HISTORIC AND DESIGN REVIEW COMMISSION

November 02, 2022

HDRC CASE NO: 2022-399
ADDRESS: 363 NORTH DR
LEGAL DESCRIPTION: NCB 7026 BLK 5 LOT 16, E11 FT OF 18
ZONING: R-6, H
CITY COUNCIL DIST.: 7
DISTRICT: Monticello Park Historic District
APPLICANT: Thomas Gandy/GANDY THOMAS R
OWNER: Thomas Gandy/GANDY THOMAS R
TYPE OF WORK: Exterior modifications, fenestration modifications
APPLICATION RECEIVED: July 24, 2022
60-DAY REVIEW: Not applicable due to City Council Emergency Orders
CASE MANAGER: Edward Hall

363 NORTH DRIVE, SAN ANTONIO, TX	
DEMOLITION FLOOR PLAN AND ELEVATIONS	
DATE: 03.23.2022	Sheet Number

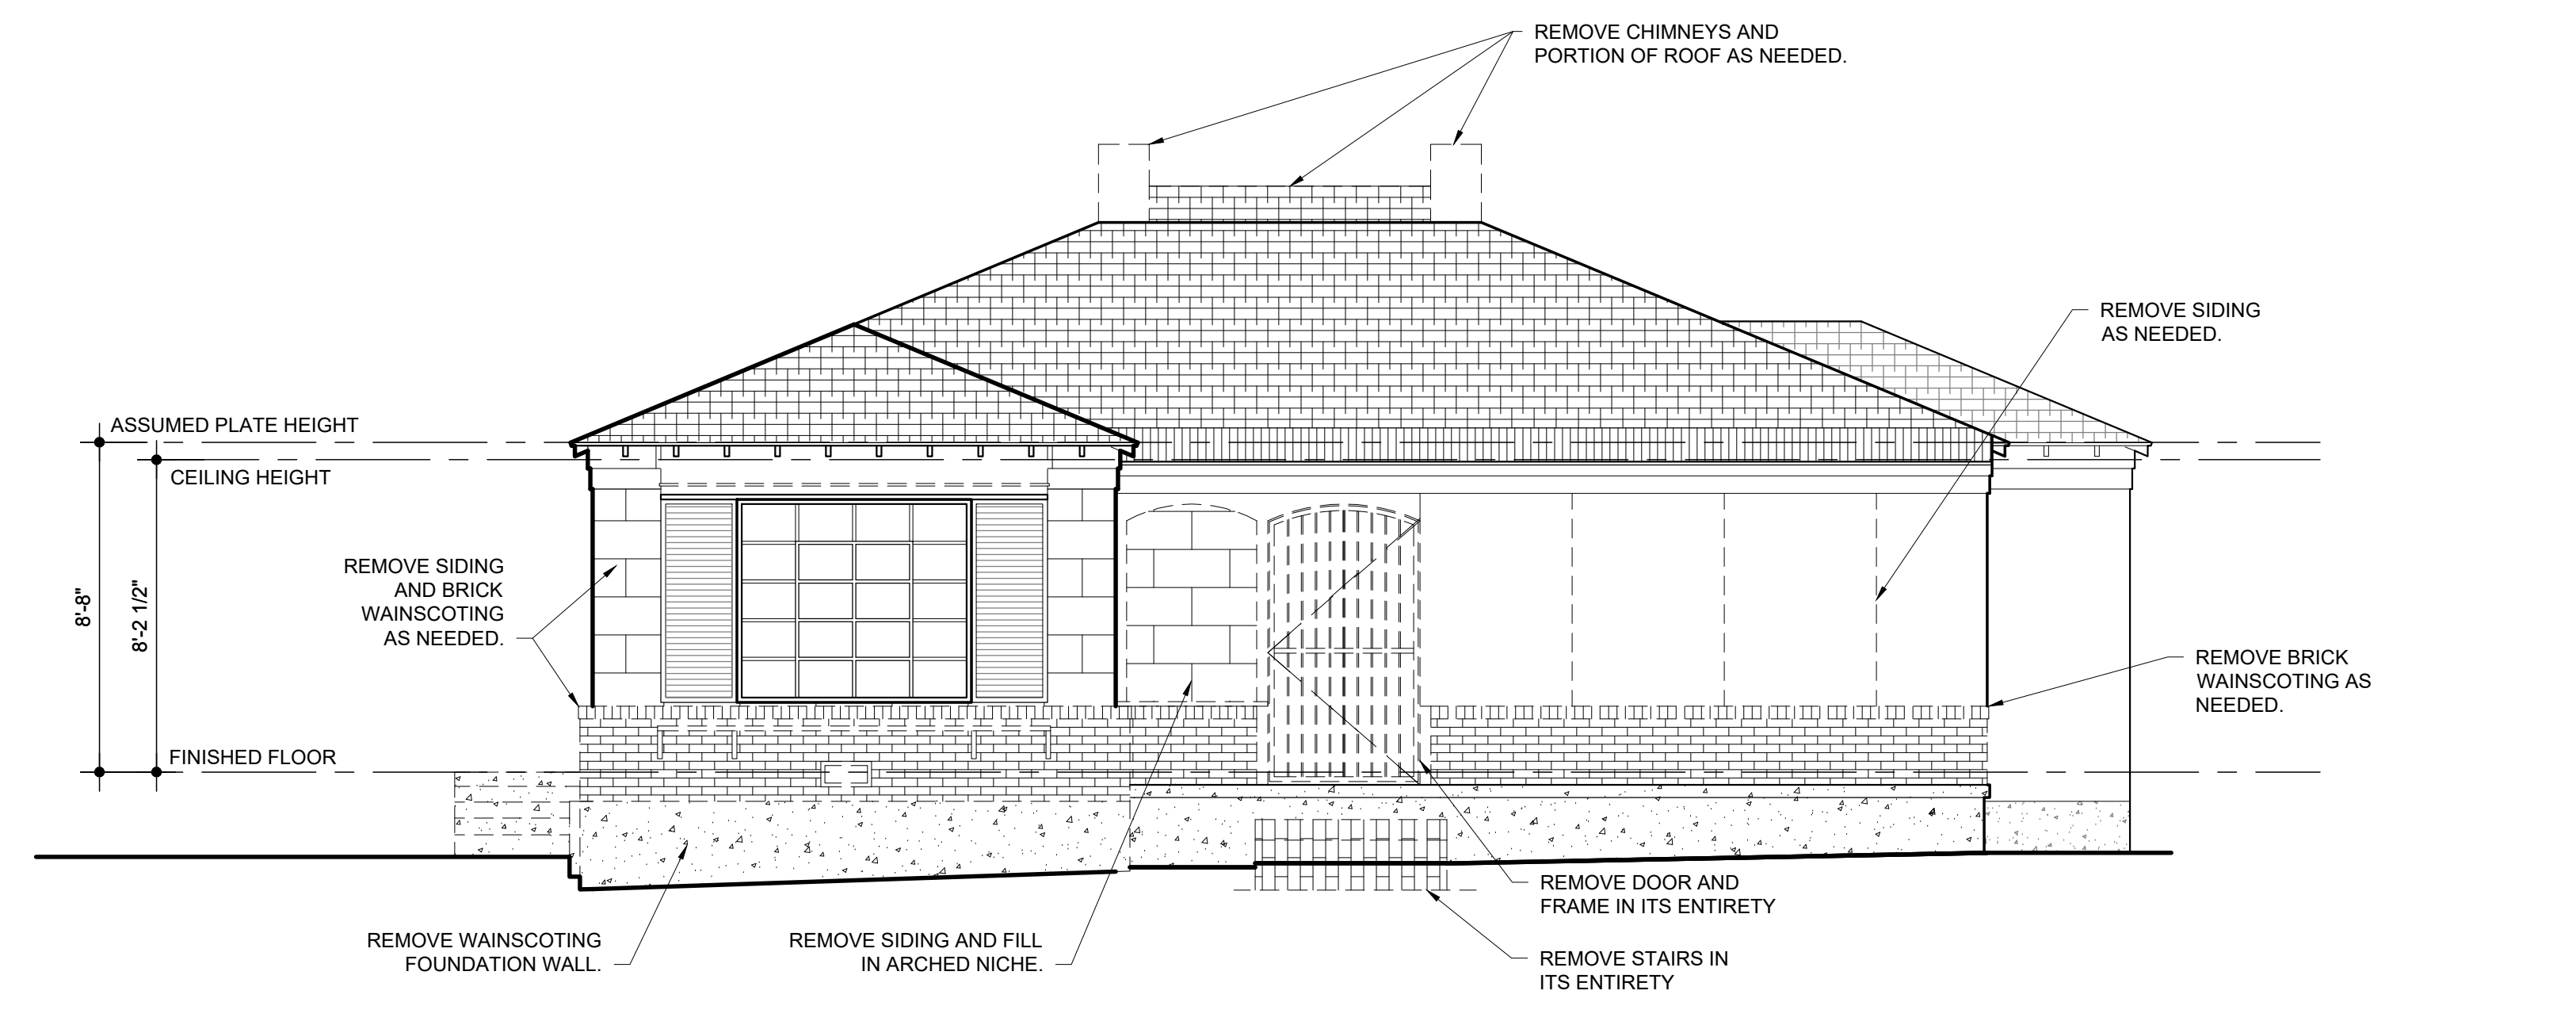
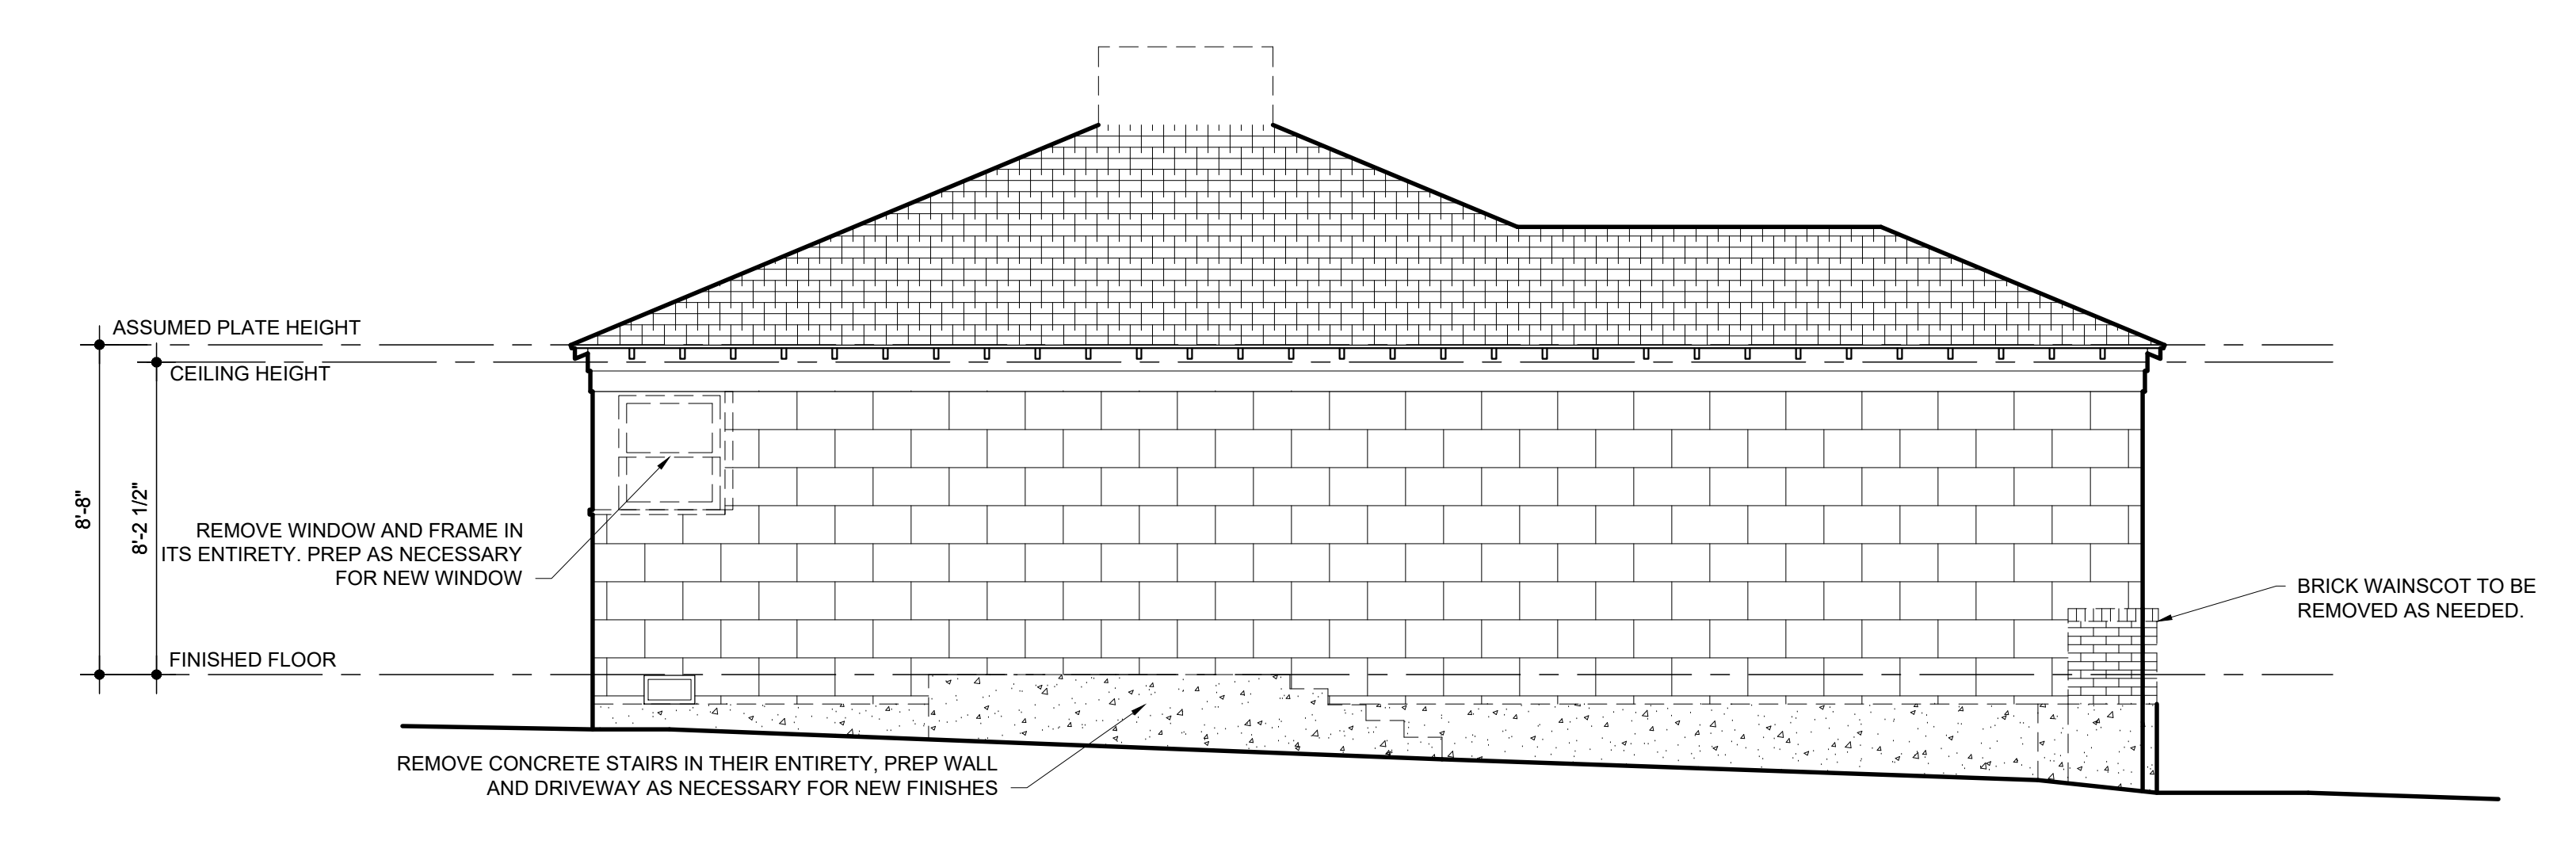
- f. EXTERIOR MODIFICATIONS (Front Façade) – The applicant has proposed to perform modifications to the front façade to include the installation of two, one over one windows on the front façade. This wall plane is not original and is the front of a previously enclosed front porch. The Guidelines for Exterior Maintenance and Alterations 7.A and B. note that front porches should not be enclosed. When porches are enclosed, the Guidelines note that they should function and visible read as a porch. Per photos, the front porch has been enclosed with screening elements since 2007, at least. Staff finds that either windows should be added across the entirety of the enclosed porch to read as an open element with visible porch columns, or that the structure should be returned to its previous condition.

- g. EXTERIOR MODIFICATIONS (Side Façade) – The applicant has proposed to perform modifications to the side (west) façade to include the removal of an existing door opening, and the removal of an existing concrete stoop and steps. Per the Guidelines for Exterior Maintenance and Alterations 6.A.i., exiting window and door openings are to be preserved. The proposal to remove the existing, side door is inconsistent with the Guidelines.

- h. FRONT PORCH STEPS – The applicant has proposed to install new, rounded concrete porch steps as well as a concrete apron to the proposed porch steps. The existing steps are clad in brick, but feature a minimal design and a width that is slightly wider than that of a pedestrian door opening. There is no historic precedent of an alternative porch design on site or within the district. Staff finds that the existing porch steps form should be maintained. In-kind replacement, with concrete would be appropriate, with no change to profile.

2. Staff does not recommend approval of item #2, modifications to the front façade, as noted in finding f. Staff recommends that either windows be added across the entirety of the enclosed porch to read as an open element with visible porch columns or that the structure be returned to its previous condition.

3. Staff does not recommend approval of item #3, modifications to the side (west) façade to include the removal of an existing door opening, and the removal of an existing concrete stoop and steps, as noted in finding g. Staff recommends that the door opening, concrete stoop and stairs be preserved.

4. Staff does not recommend approval of item #4, the installation of new, rounded concrete porch steps and a concrete apron as noted in finding h. In-kind replacement, with concrete would be appropriate, with no change to profile.
